RAAF ADDITION
SEDGWICK COUNTY, KANSAS

S/D 98-46 - Revised One-Step Final Plat of RAAF ADDITION

STAFF REPORT

CASE NUMBER: S/D 98-46 - RAAF ADDITION

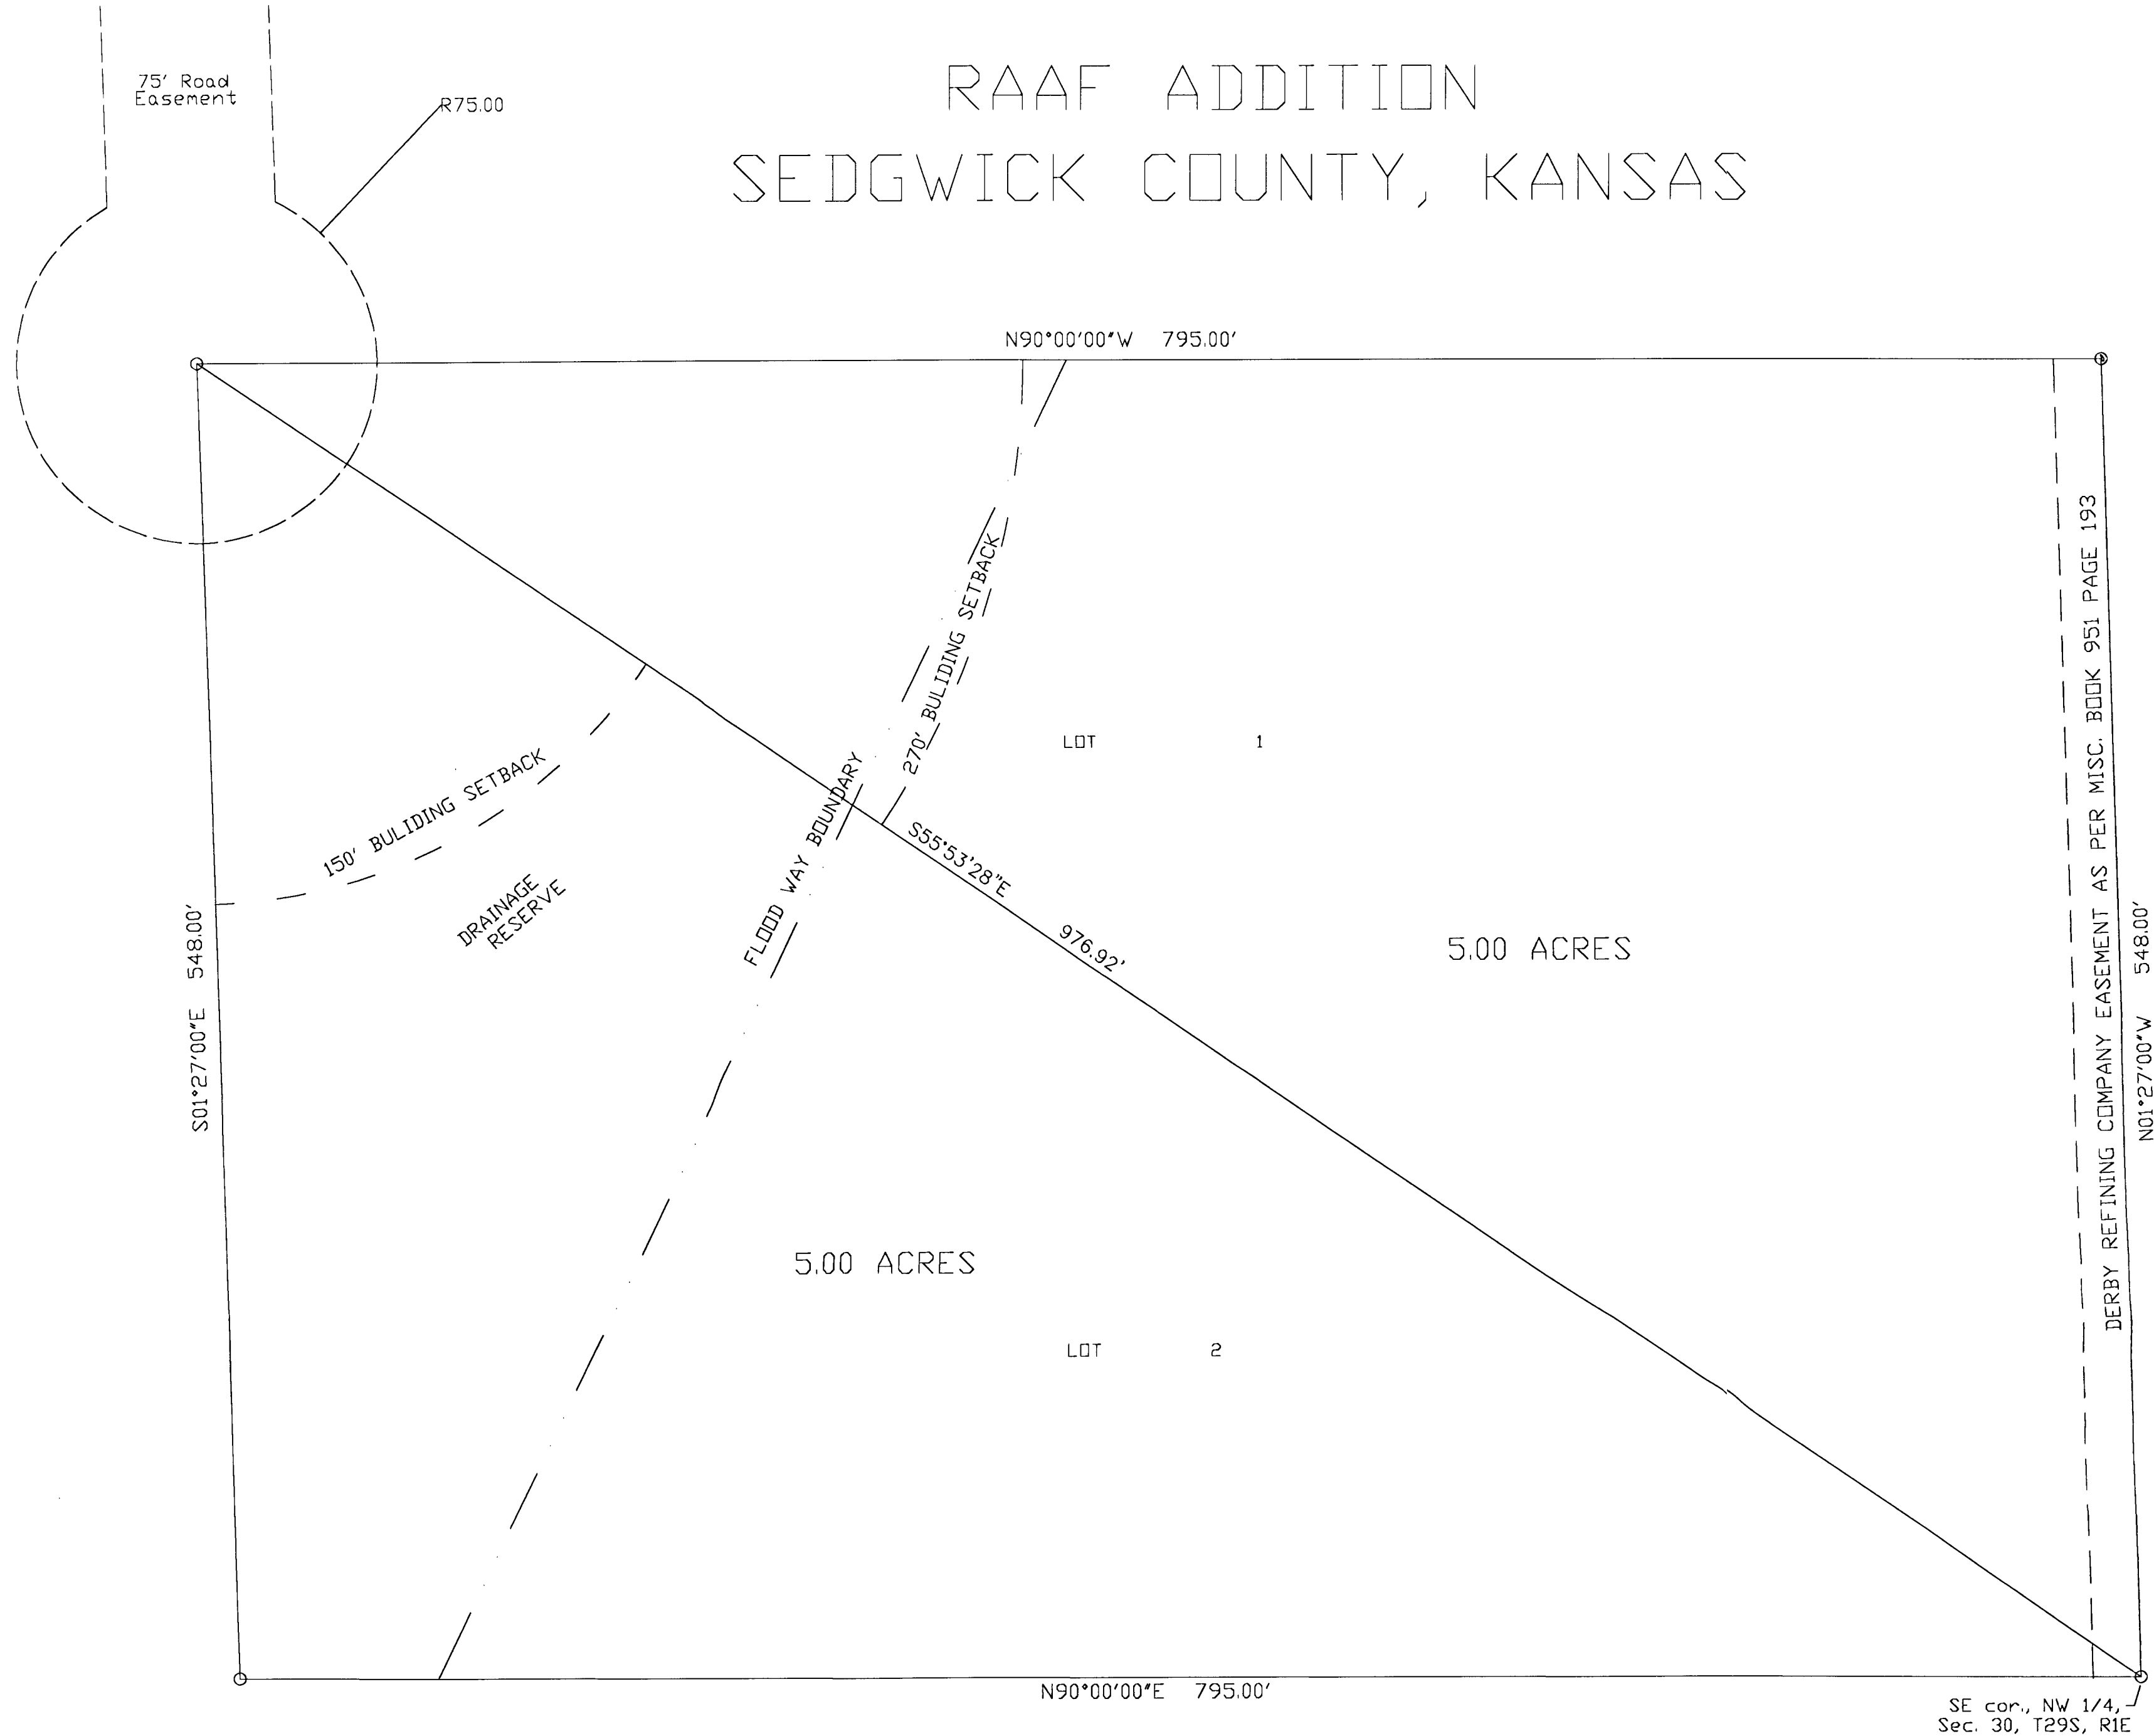
- E. The platting binder indicates two pipeline easements which are not denoted on the plat. Verification must be provided by the pipeline companies that both pipeline easements are located off-site or have been released.

- F. Lot 1 does not conform with the 200-foot lot width requirement of the RR district. An increase in the distance of the building setback from the road would enable the lot to meet the standard.

- G. The dimension for the west line of the plat does not correlate with the legal description and should be corrected on the final tracing.
- H. The applicant shall install or guarantee the installation of all utilities and facilities which are applicable and described in Article 8 of the MAPC Subdivision Regulations. (Water service and fire hydrants required by Article 8 for fire protection shall be as per the direction and approval of the Chief of the Fire Department.)

- N. Recording of the plat within thirty (30) days after approval by the City Council and/or County Commission.
- O. The representatives from the utility companies should be prepared to comment on the need for any additional utility easements to be platted on this property.
- P. The applicant is reminded that a disk shall be submitted with the final plat tracing to the Planning Department detailing this plat. This will be used by the City and County GIS Department.
- Q. The names in the signature blocks for of the Register of Deeds and the Deputy should be corrected to read, "Bill Meek" and "Linda Kizzire".

- E. The platting binder indicates two pipeline easements which are not denoted on the plat. Verification must be provided by the pipeline companies that both pipeline easements are located off-site or have been released.

- F. Lot 1 does not conform with the 200-foot lot width requirement of the RR district. An increase in the distance of the building setback from the road would enable the lot to meet the standard.

- G. The dimension for the west line of the plat does not correlate with the legal description and should be corrected on the final tracing.

Q. The names in the signature blocks for of the Register of Deeds and the Deputy should be corrected to read, "Bill Meek" and "Linda Kizzire".
